Backfeed in a 4-pair context v103

Lennart Yseboodt

Philips Lighting – Research

April 6, 2018

4-pair backfeed

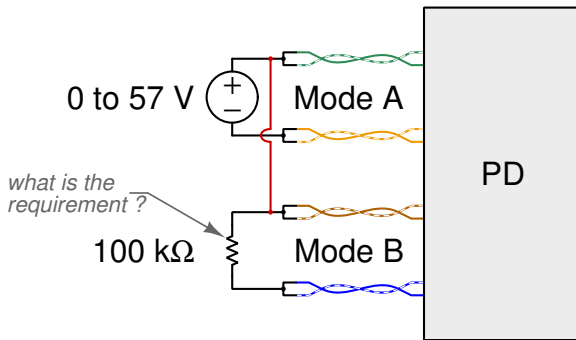
A 4-pair capable PSE typically ties the positive lines together at the PSE end. Even in “2-pair” mode, there are two pairs connected to the positive V_{PSE} . **Does the backfeed requirement still apply? Should it?**
